Ensuring Data Integrity on the i.MX35 EMI

by *Multimedia Applications Division*
Freescale Semiconductor, Inc.
Austin, TX

This Engineering Bulletin explains the technique required to minimize the size of these transient pulses in i.MX35-based designs to ensure SDRAM data integrity. The following devices are affected by this document:

Figure 1. Representative Scope Trace of Transient During a Write Cycle

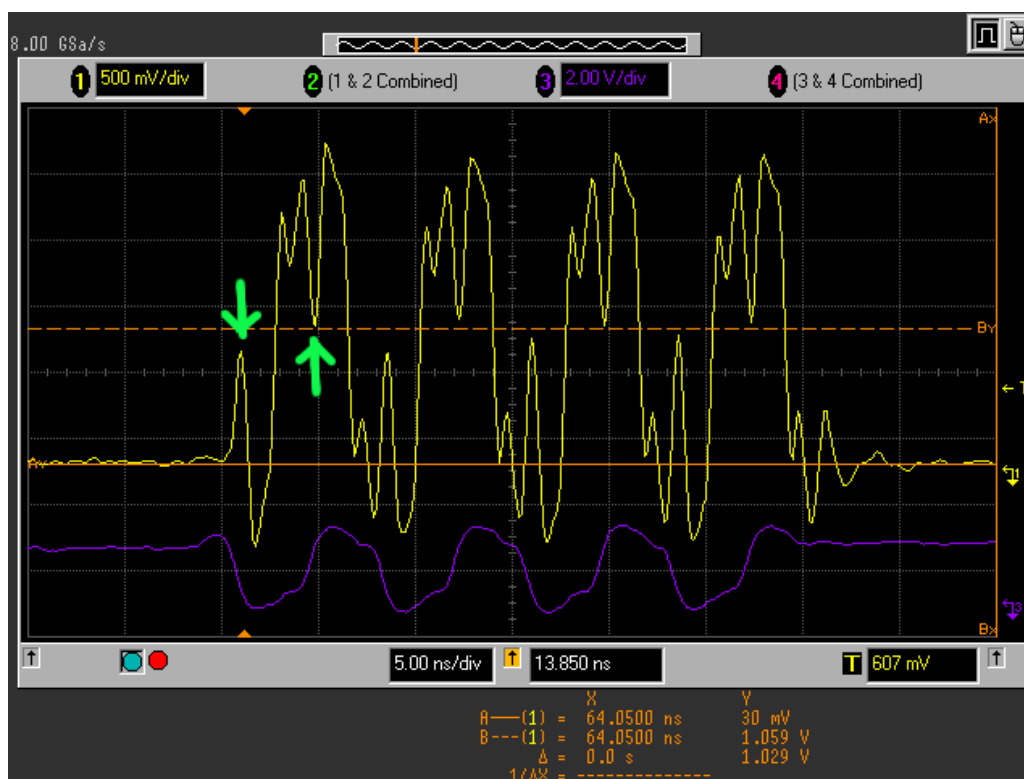
Figure 1 shows a scope plot of the transients on the DQS0 signal. The transients were captured as two words 0x00000000 and 0xFFFFFFFF were written sequentially to the bus on the first two transitions of the DQS0 signal (yellow trace). The SD31 data signal is included in the plot (purple trace). Only two words were written to the bus, but due to the internal operation of the EMI block, the same two words are alternately written to the bus through the remaining six words of the 8-word burst. This data sequence stimulates the worst case transient response from the silicon revision TO2.0 i.MX35 device.

The first two transients corresponding to the two written words are marked in Figure 1 with green arrows. The horizontal cursor marks the highest positive-going transient in the burst. In this plot, the transient magnitude is 1.029 V, which exceeds the maximum VIL ($0.3 \times NVCC_EMI$) for mDDR memory. Although the thresholds are different for DDR2 memory (dynamic limits relative to Vref), errors may still

Figure 4. Partial Schematic of Filters Placed on DQS[0:3], SDCLK, and SDCLK_B Signals

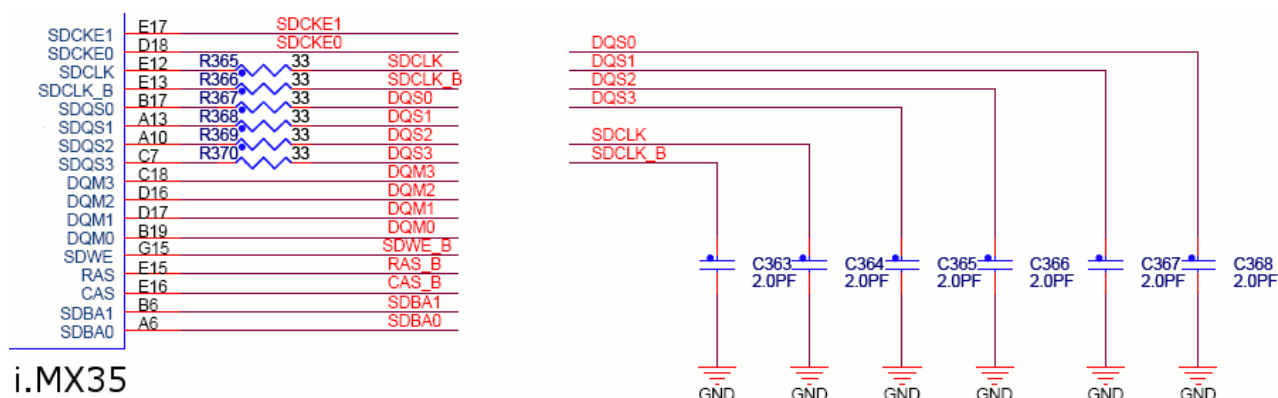
For existing, qualified designs using the TO2.0 silicon revision, the addition of transient suppressing RC filters to all four DQSx signals as well as the SDCLKD and SDCLK_B lines is recommended. These filters consist of a series resistor with a capacitor placed as closely as possible to the memory device. The filtering scheme used on the i.MX35 mDDR CPU card is shown in a partial schematic in [Figure 4.](#)

The values for the series resistor and the terminating capacitor should be the same for all six signals. The size of the resistor and capacitor requires an iterative procedure where the parameters of the i.MX35 device and package, the external memory device and the application board are all entered into a complex model for the transient behavior. The process is iterative because the selection of the component values requires balancing all system requirements for bus timing, threshold levels, operating voltage and temperature of each component in the system.

For the i.MX35 mDDR CPU card, the component values chosen were a series resistance of 33 Ω and a termination capacitance of 2 pF. The RC filters were added to the SDCLK and SDCLK_B clock lines to keep any skew between the DQSx signals and these clock lines to a minimum.

Figure 5. Scope Capture of Filtered DQS0 Signal

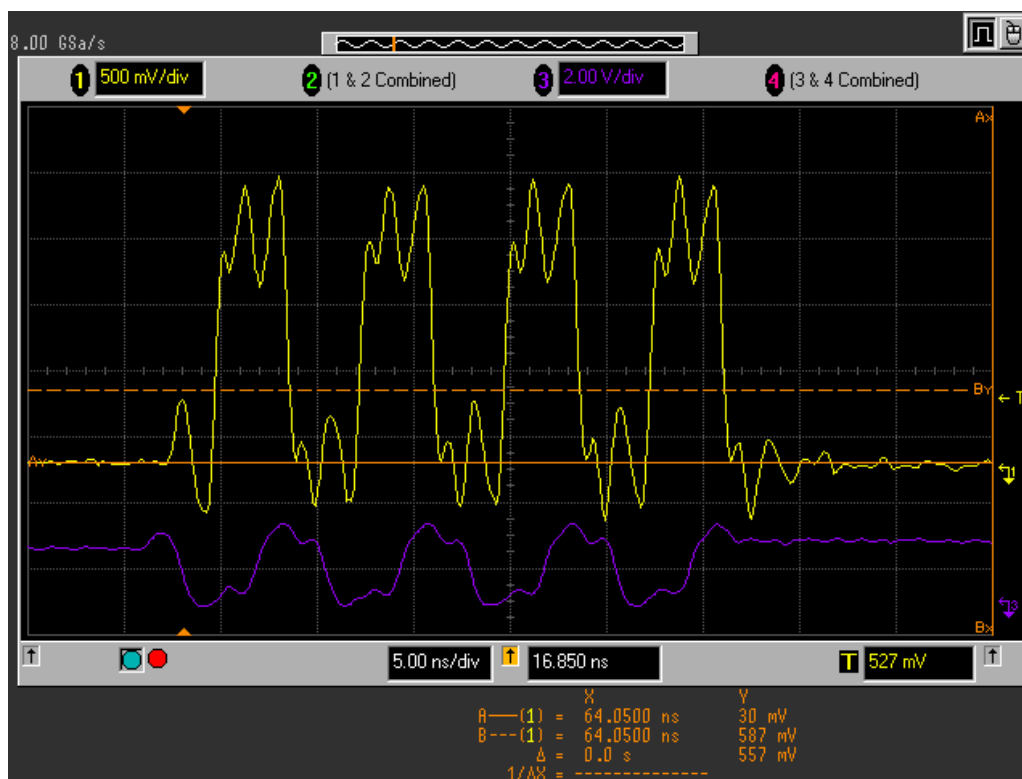
Figure 5 shows a scope trace for a i.MX35 TO2.0 mDDR CPU card with the RC filter (33 Ω and 2 pF) implemented. The conditions for Figure 5 are identical to those of Figure 1, with the exception that Figure 5 uses the drive strength configuration of SDRAM/MAX for the data lines and MDDR/HIGH for the remainder of the EMI signals.

The transient level in Figure 5 is reduced by about half. The waveform easily meets DDR2 threshold requirements. For mDDR, the maximum VIL permitted is $0.3 \times NVCC_EMI$, which for a value of 1.8 V, VIL would be equal to 0.54 V. For this board, slightly more resistance can be used to reduce the maximum transient level even further.

Figure 6. Partial Ball Map for i.MX35 TO2.1

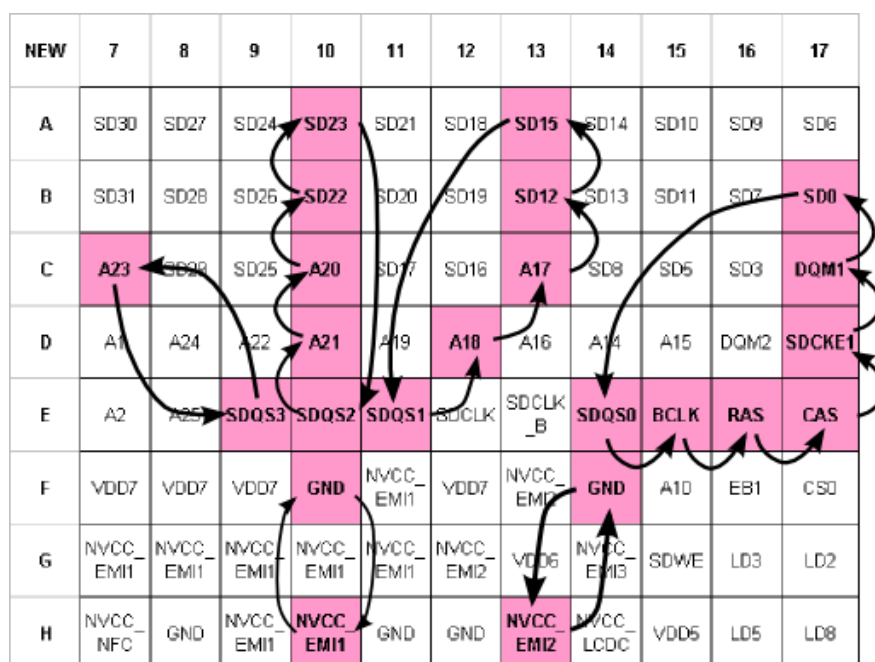
- DQSx signals are bonded with the shorter, inner row of bond wires
- Substrate routing between the bond and ball pads is greatly improved
- Twenty three signals are shifted to move the DQSx signals closer to the power supply balls

The last two improvements work together. Moving the DQSx balls closer to the power supply region and improving the substrate routing, greatly reduces the return path both on the application board as well as on the i.MX35 package substrate. Figure 6 shows a partial ball map of the revised package where the 23 signals that were moved relative to TO2.0 are highlighted in pink. The arrows show the location from where each signal was moved.

Ball	Old Pinout (TO2.0) Signal	New Pinout (TO2.1) Signal
A10	DQS2	SD23
A13	DQS1	SD15
B10	SD23	SD22
B13	SD15	SD12
B17	DQS0	SD0
C7	DQS3	A23
C10	SD22	A20
C13	SD12	A17
C17	SD0	DQM1
D10	A20	A21
D12	A17	A18
D17	DQM1	SDCKE1
E9	A23	DQS3
E10	A21	DQS2
E11	A18	DQS1
E14	BCLK	DQS0
E15	RAS	BCLK
E16	CAS	RAS
E17	SDCKE1	CAS
F10	NVCC_EMI1	GND
F14	NVCC_EMI2	GND
H10	GND	NVCC_EMI1
H13	GND	NVCC_EMI2

Figure 8. Scope Capture of DQS0 with T02.1 Silicon

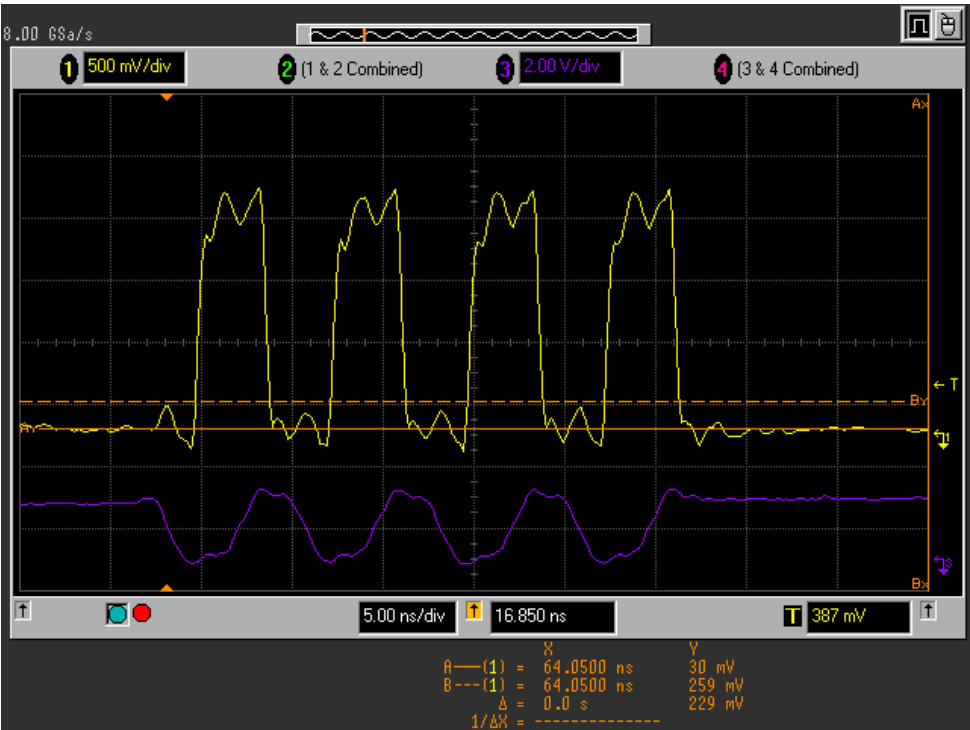
The i.MX35 mDDR CPU card was re-laid out for the TO2.1 silicon revision ball map with minimal changes to the existing filtered mDDR board layout. Figure 8 shows an oscilloscope capture of the DQS0 signal from the revised TO2.1 mDDR CPU card with the drive strength set to SDRAM/MAX for the data

lines and MDDR/HIGH for the remainder of the EMI signals. The transient level is reduced by half again as much as the filtered TO2.0 DQS0 signal seen in [Figure 5](#).

[Figure 9](#) is included to emphasize the fact that the most significant contributors to the root cause of the transient were correctly identified and resolved by shortening the bond wires, improving the substrate routing and revising the ball map. Even with all the drive strengths set to DDR2, the maximum

configurable drive strength, the transient level in Figure 9 is still about half of that seen in Figure 1, which used MDDR/HIGH for all the signals.
